**NARRATIVE
92 HALLEY DRIVE
19.17-1-36
POMONA, NEW YORK**

Re: Planning Board Applications for:
92 Halley Drive – 19.17-1-36

Nelson Pope Voorhis Review Letter dated September 5, 2023

FILE: HALLEY
DATE: FEB 10, 2024
SCALE: 1" = 20'
SHEET: 3 OF 4

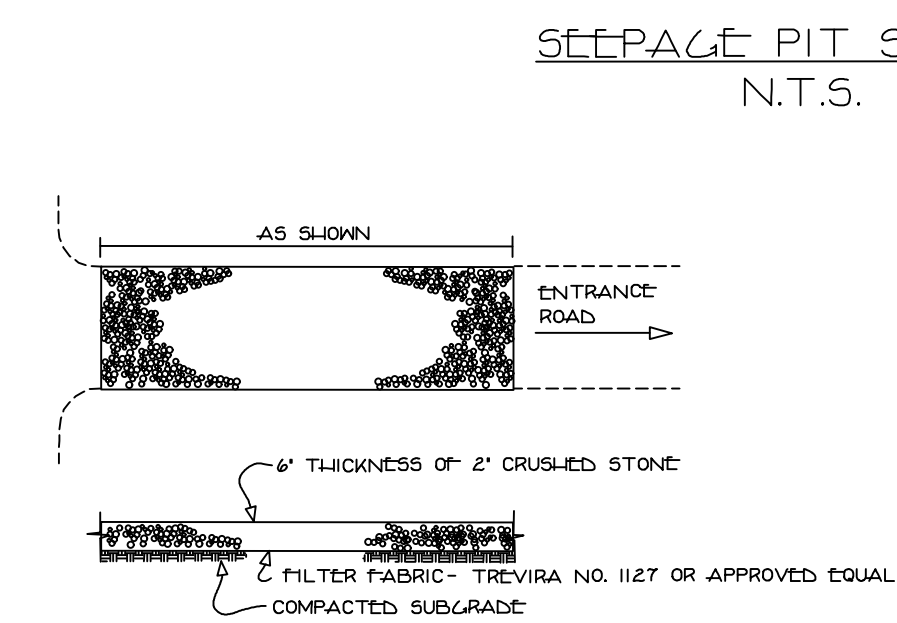
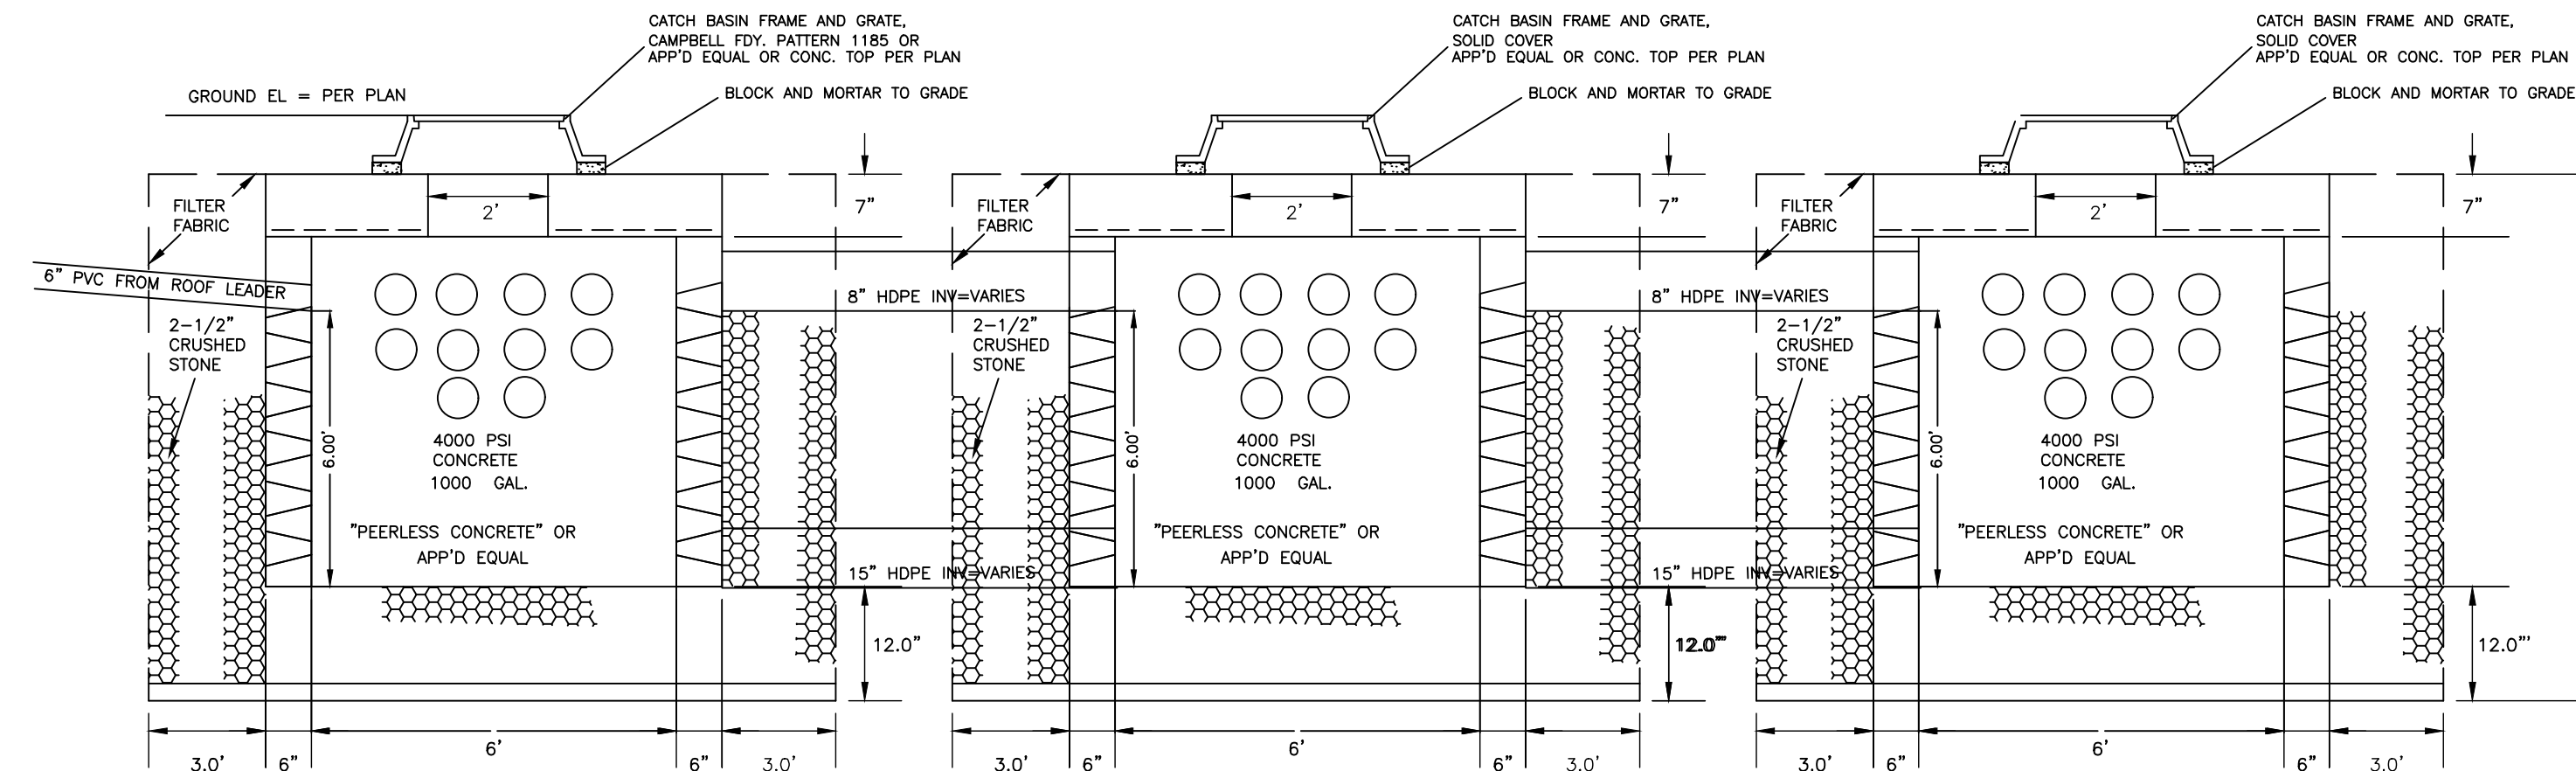
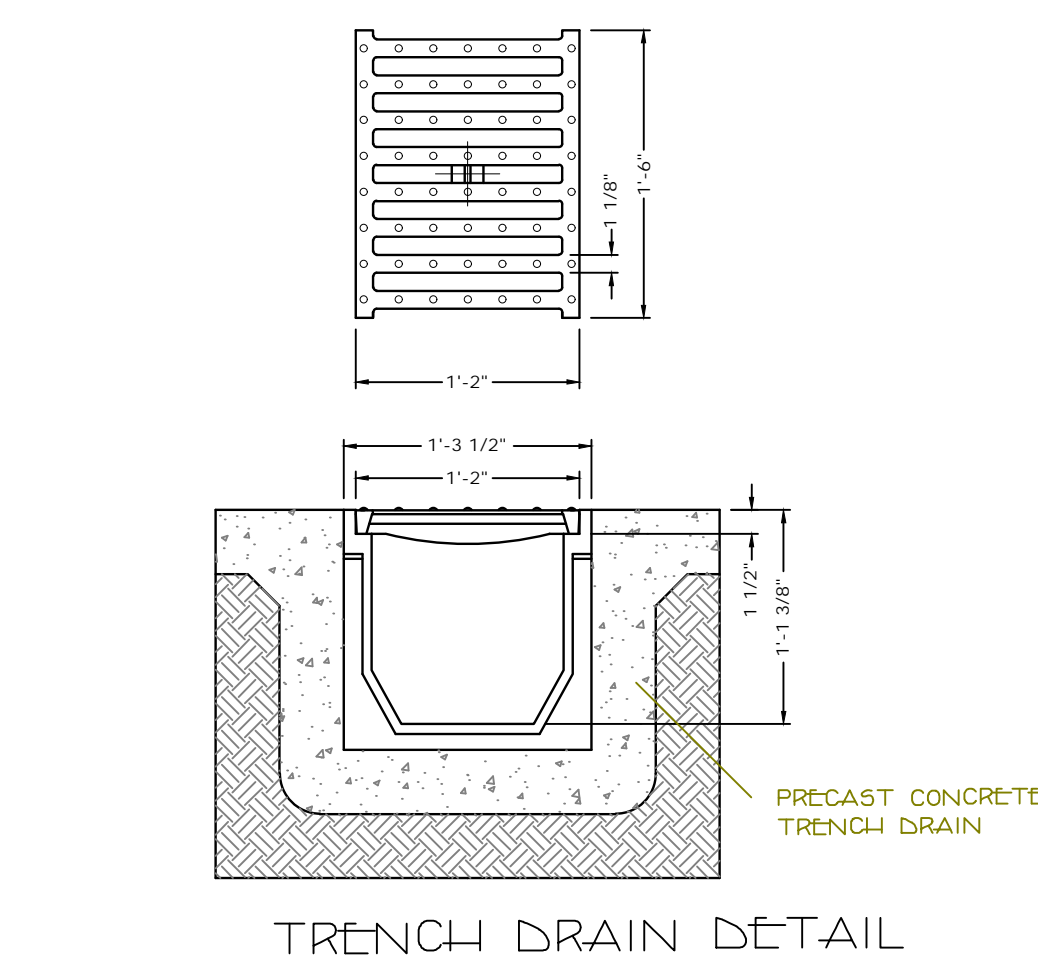
- 22) S-22. Drainage analysis should address the change of land use. The existing area to be developed is classified as "fair woods"; the proposed area will be impervious and lawn area. Include the entire developed area in the analysis.

- **The drainage analysis has been revised to account for the change from fair woods to grass. The revised calculations are included on the detail sheet for each lot.**

- **All decks will be connected to the drywell systems via Trex RainEscape Deck Drainage System. The decks are now labeled accordingly and a note has been added to the drywell detail stating that all decks are to be connected to the drainage system through this product.**
